ADMINISTRATIVE AMENDMENT

COUNTRY CLUB PLAZA I
1716 CENTRAL AVE., SW
ALBUQUERQUE, NM 87104

OVERALL SITE PLAN-
FOR ADMINISTRATIVE
AMENDMENT

AA01

A5 New Post Sign Detail
1/4"=1'-0"

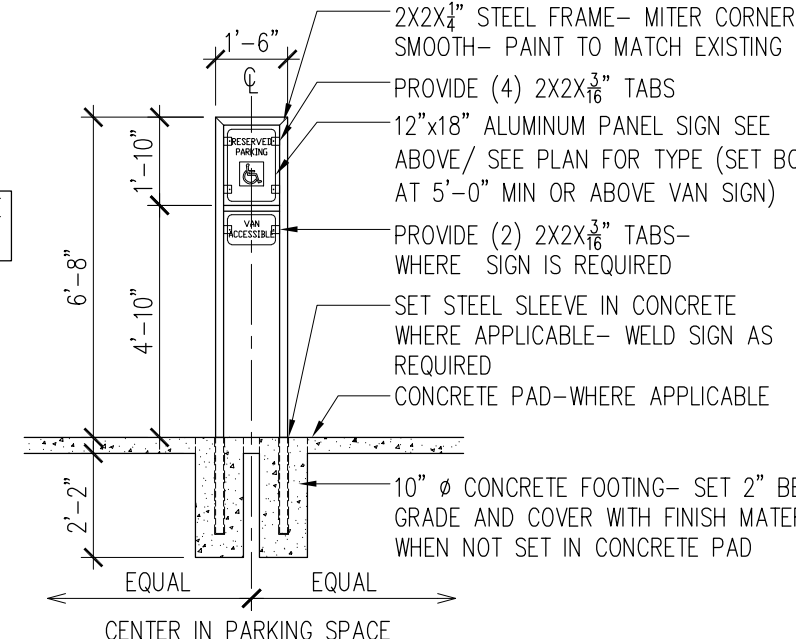
CHANGES PER TOL COMMENTS

1. ADD ADA ACCESS AISLE-8'-0" PER NEW KEYED NOTE #84
2. SIGN INFORMATION INCLUDED IN NEW DETAIL A5/AA01
3. KEYED NOTE #84 INCLUDES NOTES REQUIRING 'NO PARKING' TEXT AND REFERENCES 66-1-4.1.B NMSA 1978
4. 'MC' REFERENCE HAS BEEN REMOVED
5. NEW KEYED NOTE #85 AND #86 INCLUDE REFERENCE TO MOTORCYCLE AND HC PARKING SIGNAGE. INCLUDES REFERENCE TO DETAIL A5/TCL01. ADA AND MOTORCYCLE SIGN DETAILS ARE INCLUDED IN DETAIL A5/AA01

[68] EXISTING RETAINING WALL.
[69] EXISTING BUILDING OVERHANG ABOVE WITH REQUIRED 13'-6" HEIGHT CLEARANCE FOR FIRE APPARATUS.
[70] PAINTED ACCESS AISLE STRIPING.
[71] EXISTING STAMPED COLORED CONCRETE PEDESTRIAN CONNECTION TO MATCH EXISTING.
[72] RETAINAGE POND AREA, REFER TO CONCEPTUAL G&D PLAN.
[73] 3'-0" WIDE LEAVE-OUT IN CURB. REFER TO CONCEPTUAL G&D PLAN.
[74] EXISTING AREA DRAIN.
[75] EXISTING CONCRETE STAIR WITH HANDRAILS.
[76] EXISTING MANHOLE. REFER TO CONCEPTUAL G&D PLAN.
[77] EXISTING SIDEWALK CULVERT.
[78] EXISTING STEEL POLE UP TO 14'-0" AFF FOR STRING LIGHT EXTENSION.
[79] RECYCLING AREA
[80] GAS METER
[81] FIRE LANE ACCESS TO FDC
[82] PROPOSED CONCRETE CURB EXTENSION.
[83] EXISTING CONCRETE CURB TO BE REMOVED
[84] NEW MIN. 8'-0" WIDE X18'-0" LONG ADA VAN ACCESS ISLE-PROVIDE PAINTED 'NO PARKING' IN CAPITAL LETTERS PER 66-1-4.1.B NMSA 1978
[85] NEW HC SIGN PER DETAIL A5/AA01
[86] NEW MOTORCYCLE PARKING SIGN PER A5/AA01

WHITE SYMBOL ON BLUE BACKGROUND
SIGN FIELD= WHITE
SIGN LETTERING AND BORDER = GREEN
PROVIDE REQUIRED LANGUAGE PER NMSA 1978 66-7-352.4C-VIOLATORS ARE SUBJECT TO A FINE AND OR TOWING
6"x12" VAN ACCESSIBLE SIGN ONLY REQ'D AT HC VAN PARKING LOCATION(S)
